CONSULTEE RESPONSE (Council's Arboriculturist)

Reference: AW/67/26/T

Location: Land at the rear of 9 and 10 Faresmead, Aldwick, PO21 3DQ

Proposal: Fell 1no. beech (B6). Crown reduction to 1no. beech (B1) to leave a height of 13m and spread of 3m. Crown reduction to 3no. hornbeam (H2, H3, H7) to leave a height of 13m and spread of 3m. Crown reduction to 1no. hornbeam (H8) to leave a height of 9m and spread of 3m.

Figure 2 Positions of final cuts

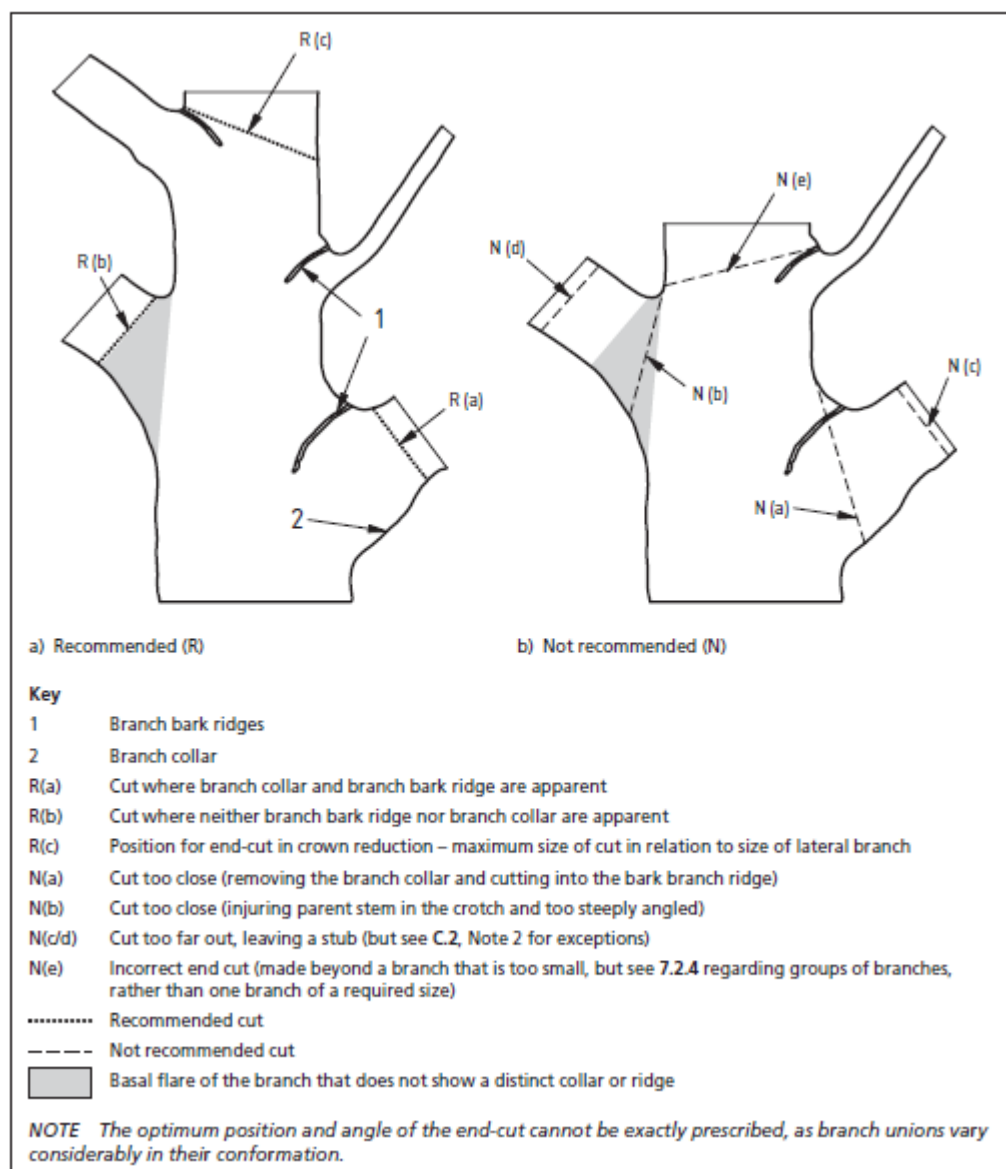
Part a) Where whole branches are to be removed and final cuts made close to the trunk or branch union they are to be made as shown in Figure 2 of BS3998:2010
